PRINCETON PLASMA PHYSICS LABORATORY
 C & D SITES
 BUILDING FLOOR PLANS

C.O.B., C.S. & R.F. BUILDINGS
 2ND. FLOOR C-SITE

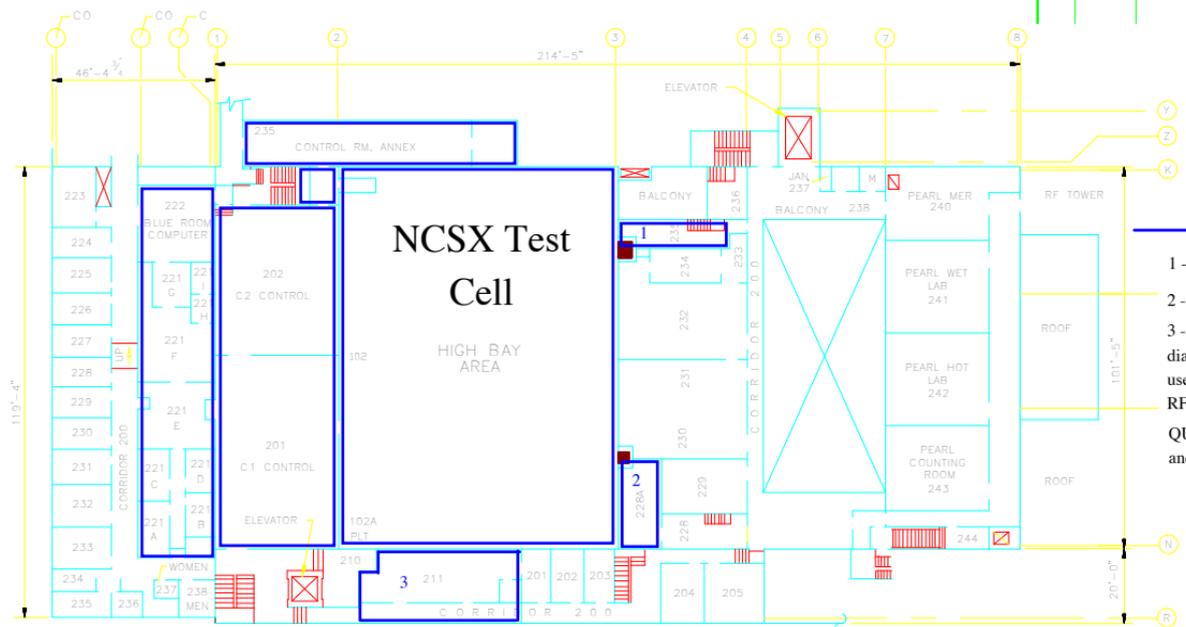
Requested by NCSX

- 1 - NCSX wants RF235 currently used by R. Kaita
 - 2 - NCSX wants RF228A currently used by RF
 - 3 - NCSX wants CS211 and its hallway for diagnostics and racks -- currently used for PBX storage and thoroughfare to HP and RF 2nd/3rd floors
- QUESTION - Will there be a radiation issue for HP and others in the RF Building during NCSX
